Service Bulletin

Using **260-0952** Alternator with Pre-2016 Stairmaster Units

Applies to: 4000-Steppers + SC916 + SC5+ FreeClimber (155015) 7000PT + SM916 + SM5+ Gauntlet (150015)

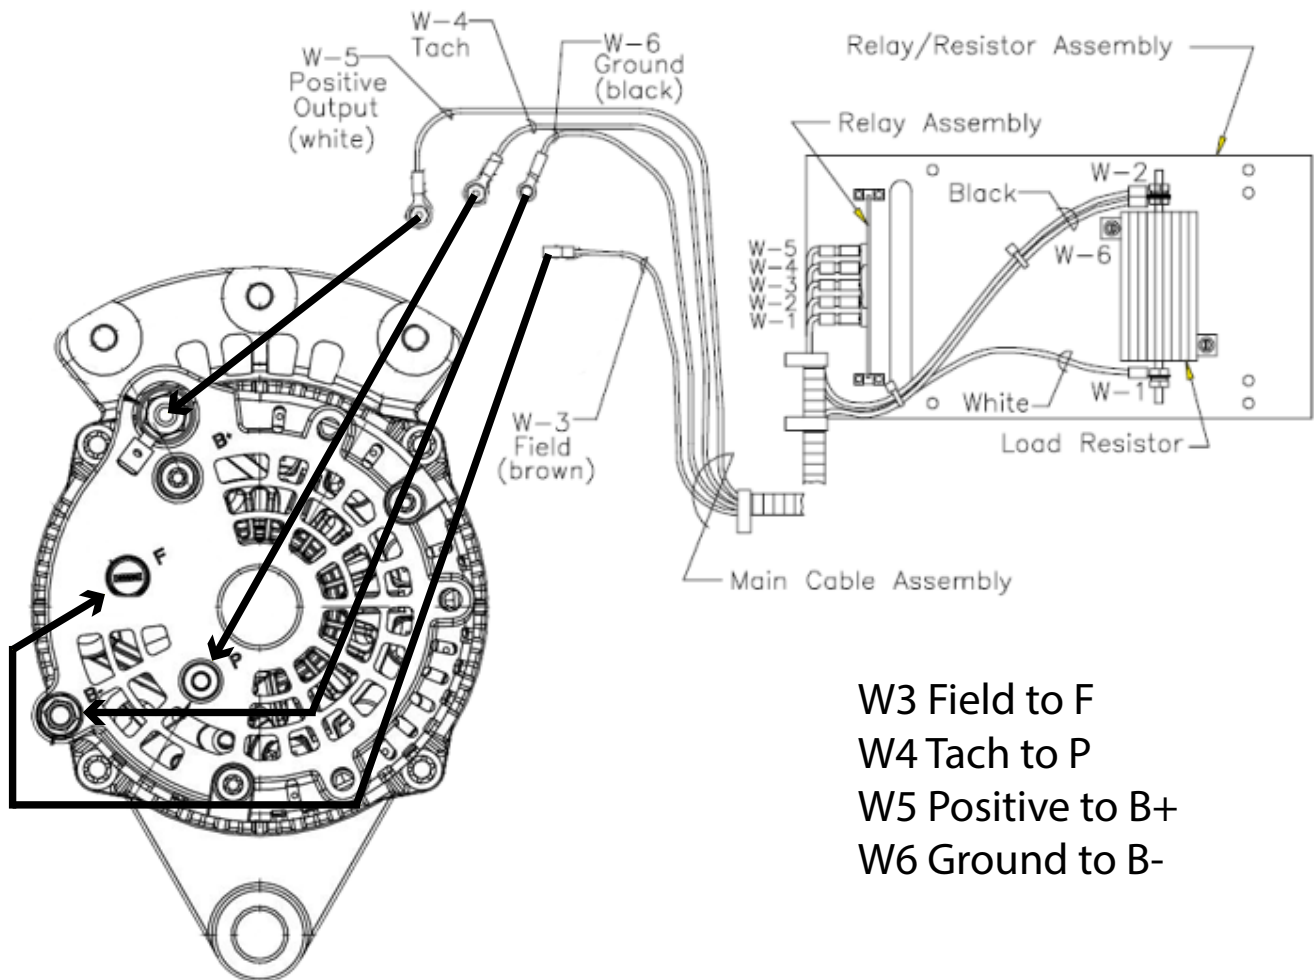
In 2018, a new alternator was introduced (**260-0952**) to replace the original Stairmaster alternator (**SM22900**). While this alternator is backwards compatible to pre-2016 units, the wires connect to it slightly different. Please see below:

- W3 Field to F
- W4 Tach to P
- W5 Positive to B+
- W6 Ground to B-
